HDVS® Display

Model: **HDM-1230, HDM-1730, HDM-2830**

Subject: **NEW E BOARD RESISTOR**

Figure 1

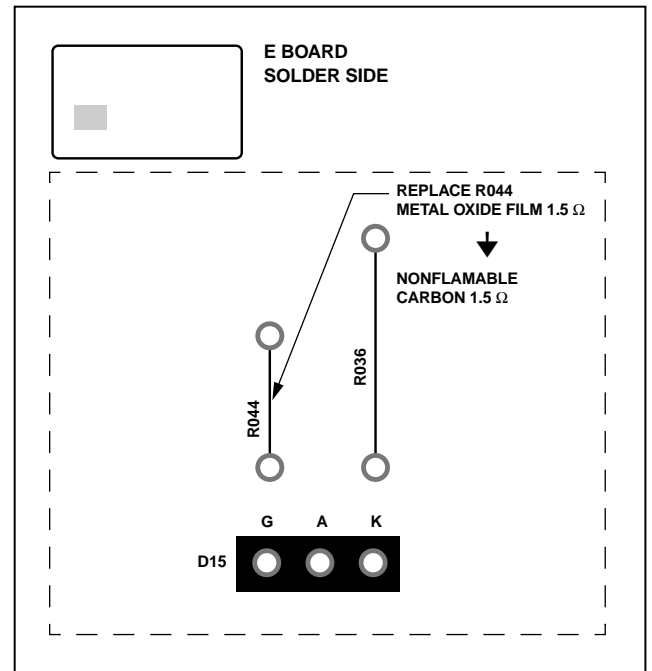
Problems in certain areas of the circuitry may cause resistor R044 on the E board to generate excess heat. To correct this condition, replace R044 with a new non-flammable carbon resistor as shown in Figure 1.

| Part No. | Description | Qty. |
|-----------------|---|------|
| 1-247-754-11* | Res, Nonflammable Carbon 1.5kΩ, 1/2W | 1 |
| 1-247-715-11** | Res, Nonflammable Carbon 1.5kΩ, 1/4W | 1 |
| 1-247-713-11*** | Res, Nonflammable Carbon 1.0kΩ, 1/4W | 1 |
